#### SIB 64 01 24

#### RYTHMIC DRUM NOISE HEARD FROM HVAC

This Service Information Bulletin (Revision 2) replaces SI B64 01 24 dated February 2024.

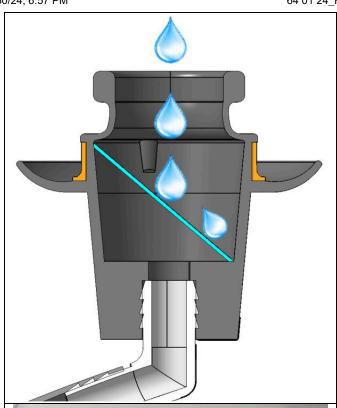
Warm temperatures combined with high air humidity may lead to the formation of condensate in the blower housing.

As a result of a high blower actuation, the formed condensate droplets are thrown vertically against the condensation drain opening at high speeds.

The resulting noise is amplified by the long condensation drainage hose, and by the geometry of the grommet and heating and air conditioning unit. These can result in an echoing effect heard from the condensate drain pipe.

A ramp insert has been placed into the condensation drain plug, so the water drops falling into the condensate drain pipe are broken up- eliminating the drumming noise.

An assembly solution was implemented as of December 31,2023 production.

For vehicles produced prior to December 31, 2023, replace the condensation water drain hose assembly.

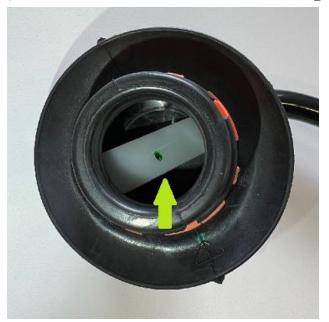
NOTE: DO NOT MODIFY the condensate drain pipe. This could allow water to collect upon the high voltage battery or back up into the HVAC box overflowing onto the vehicle floor.

The condensation drain has been optimized and can be identified by a **WHITE DOT** or revision **INDEX 02** or higher.

The optimized condensation drain can be identified by a ramp insert

Prior to installing new drain into body from below apply lubricant to the top of the seal (2) where it contacts the heater box.
